ADDENDUM 5

DATE: 05/25/22

'Matilda Torres High School, Toros Stadium'
Matilda Torres High School
16645 Road 26. Madera, CA 93638

DARDEN PROJECT NO. 0622.4
DSA File Nos. 10-C3
DSA APPL. NO. 02-118396

AD5-SX02

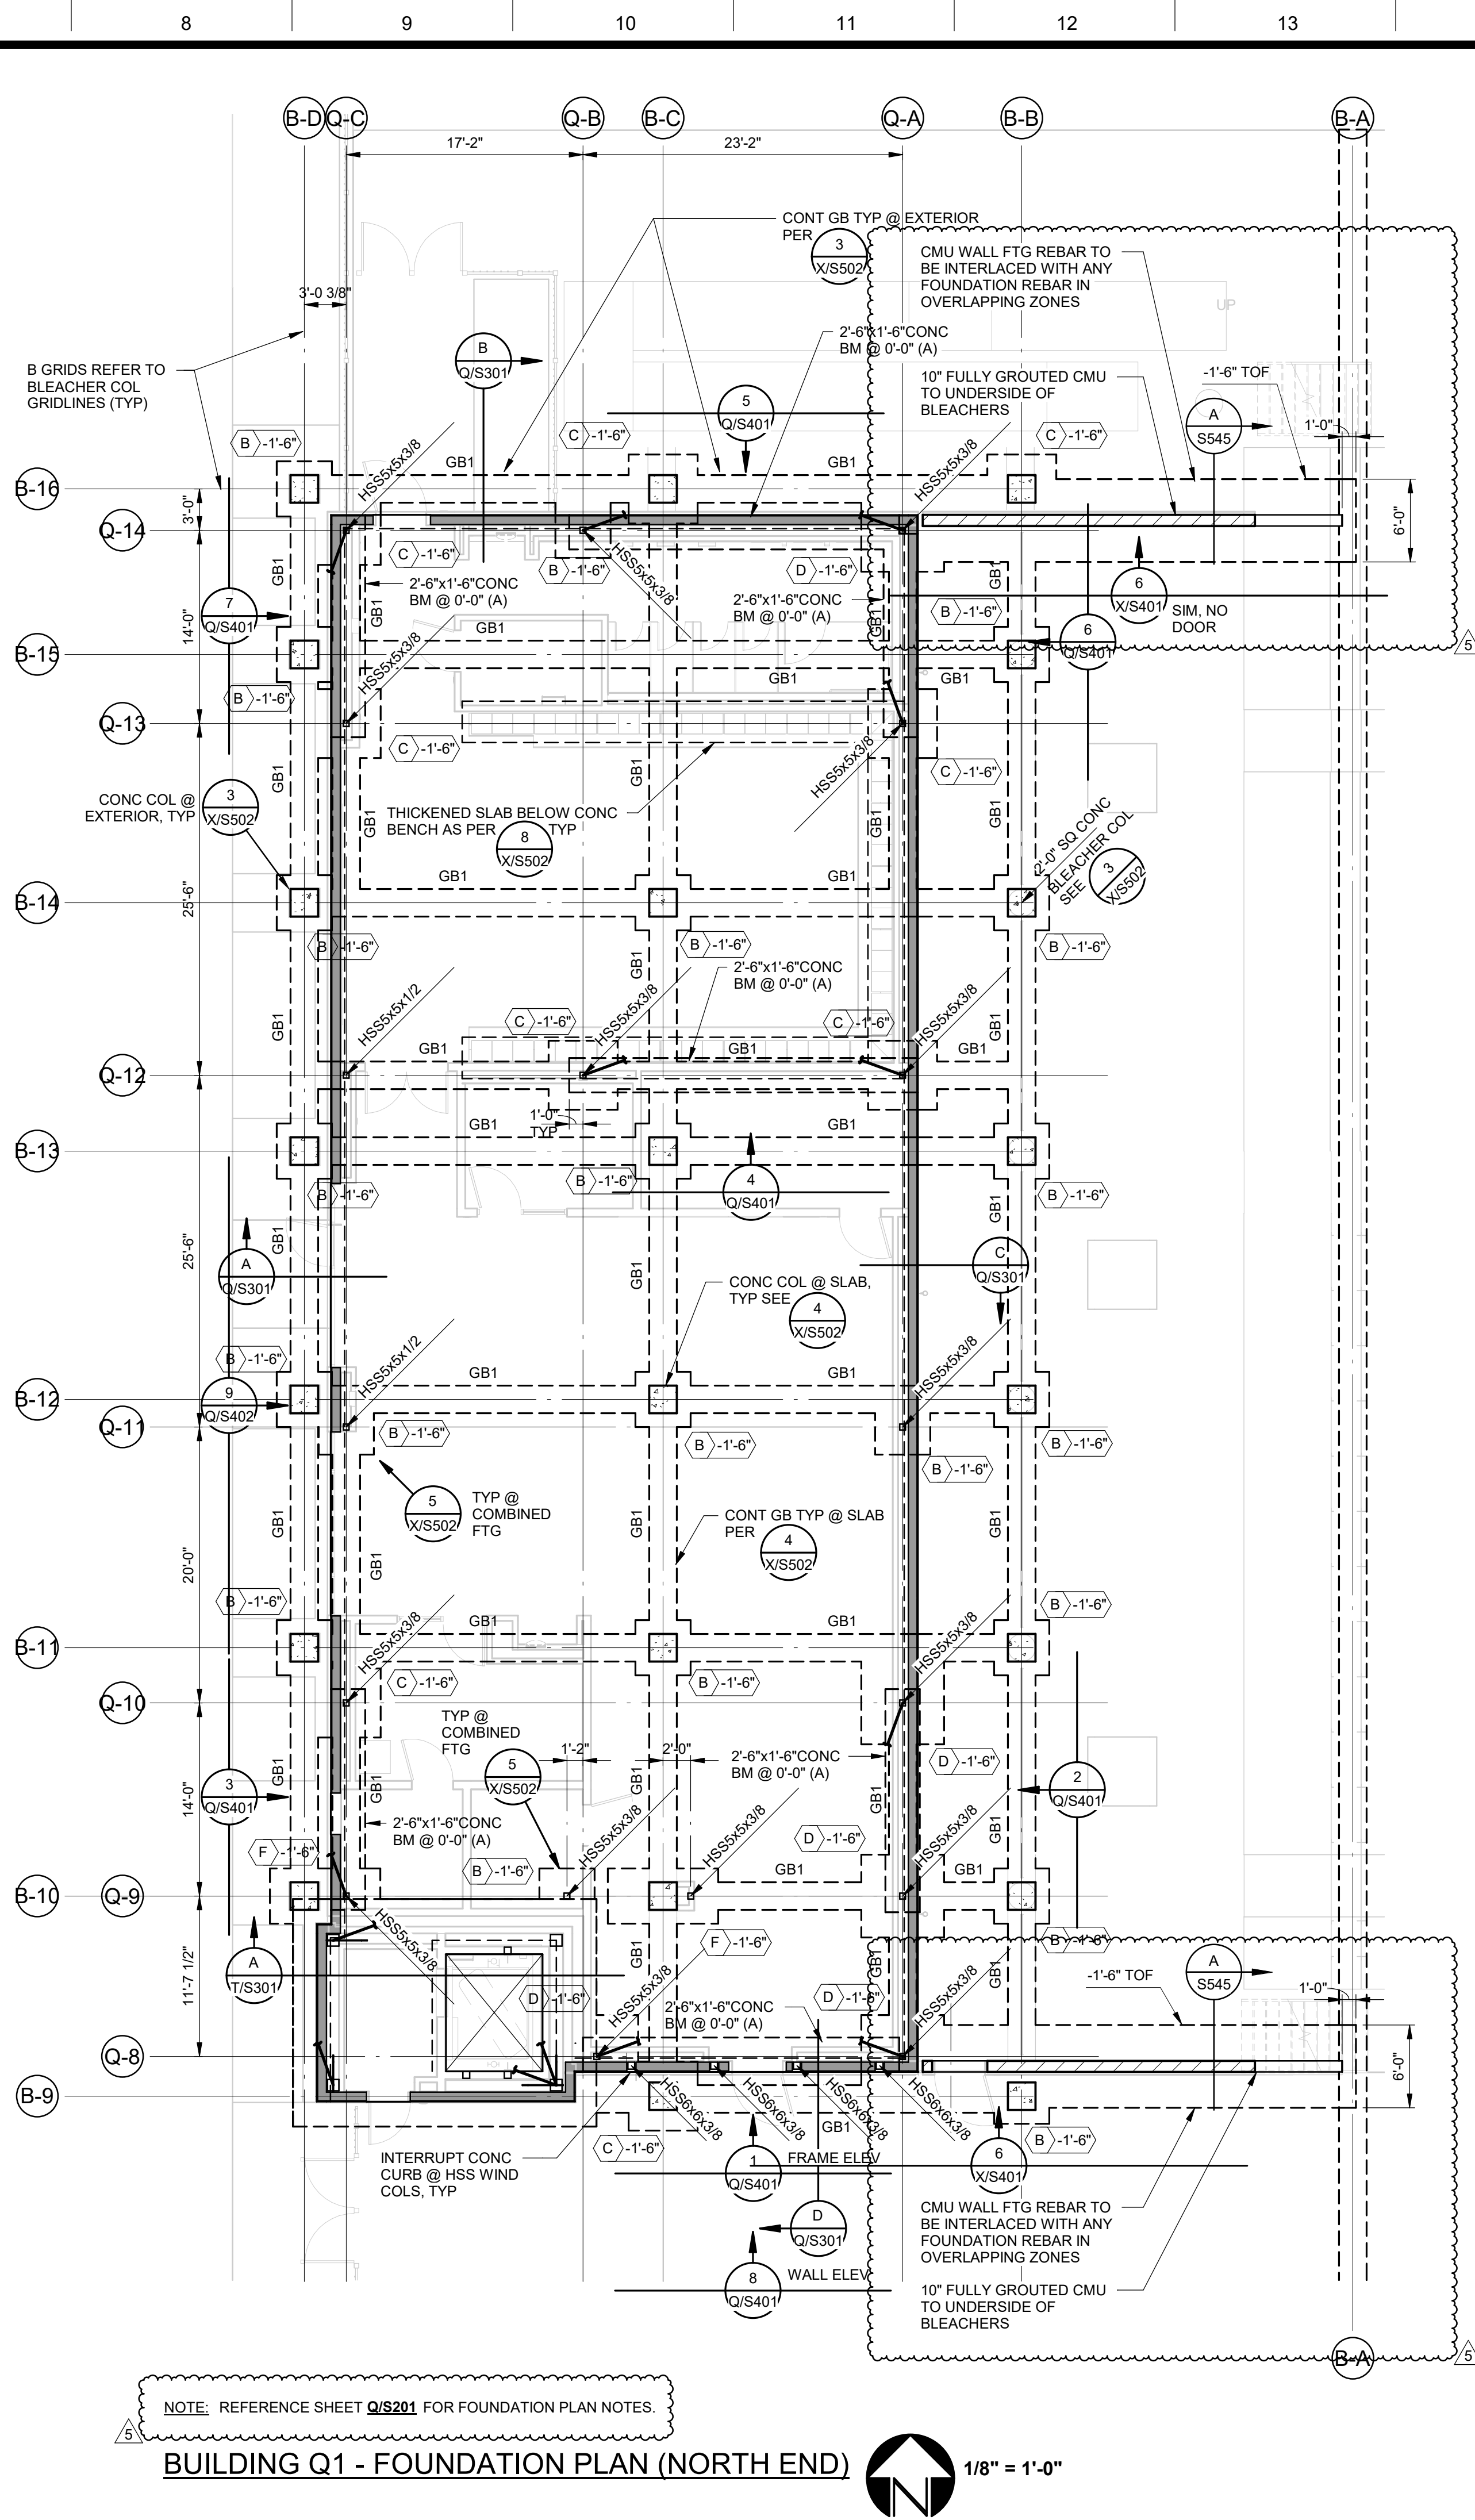
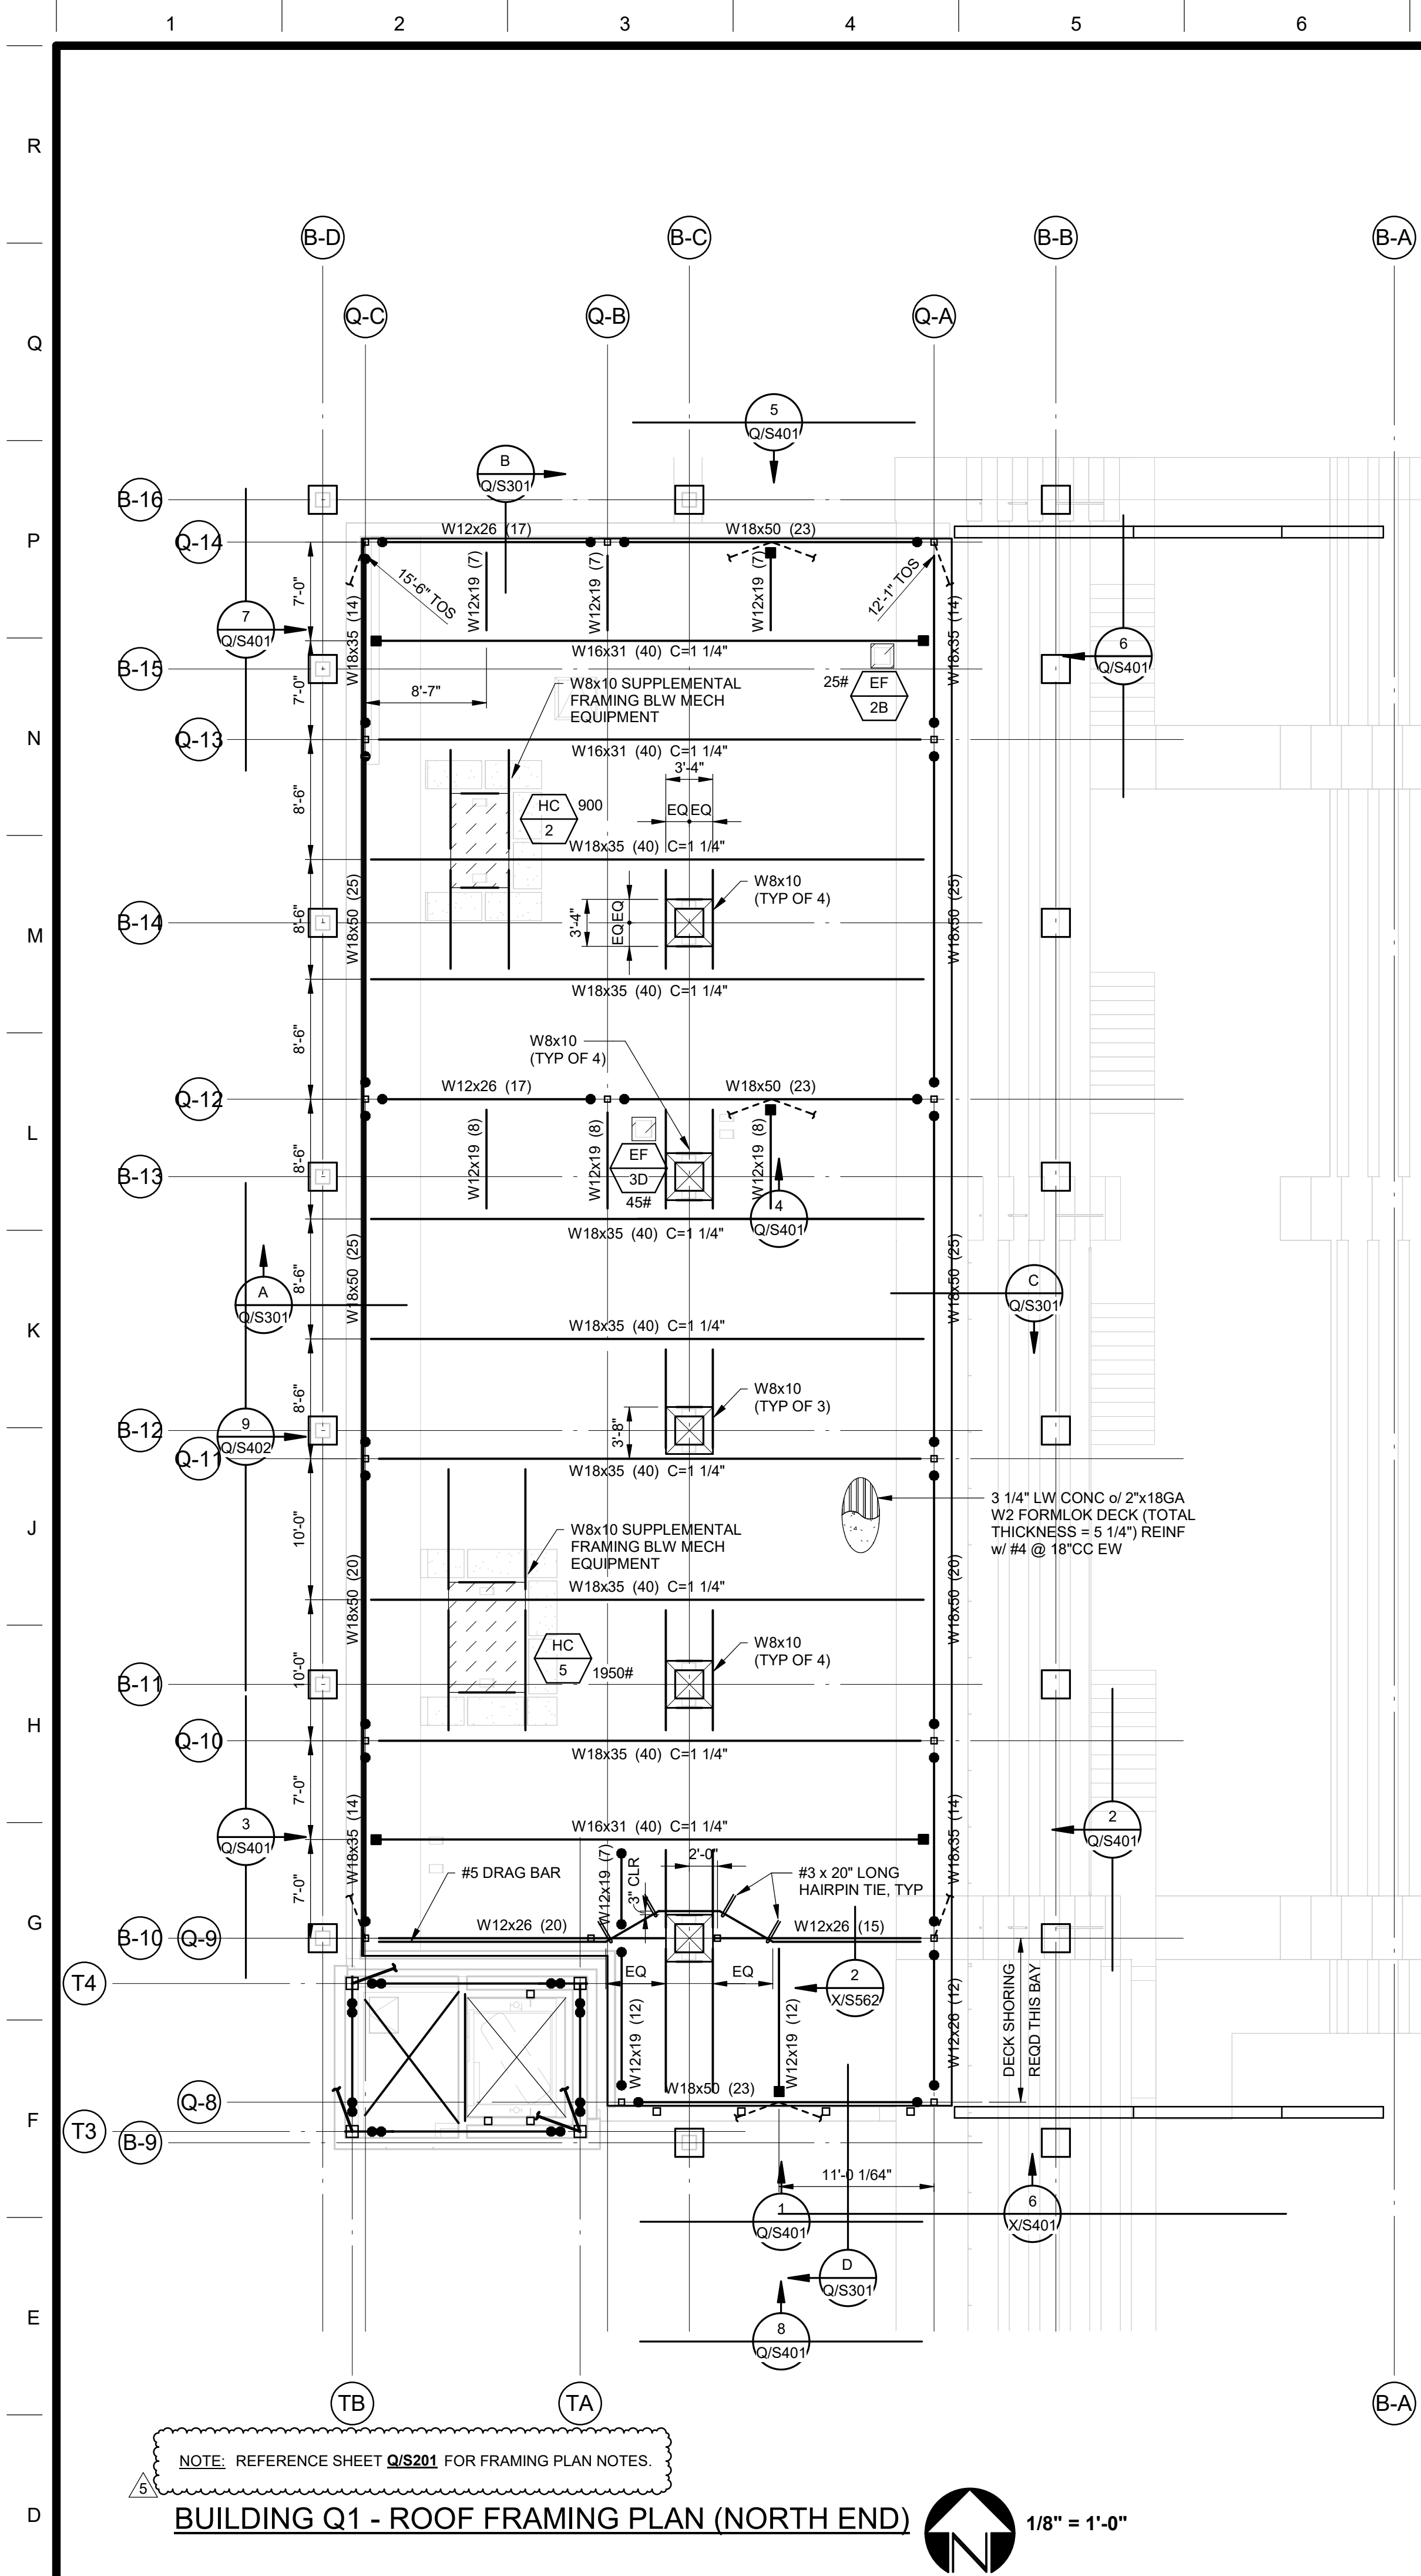
AD5-S02 Refer to Sheet Q/S202

1. Replace sheet with attached exhibit AD5-SX02
 - a. CMU wing walls and footings clarified.
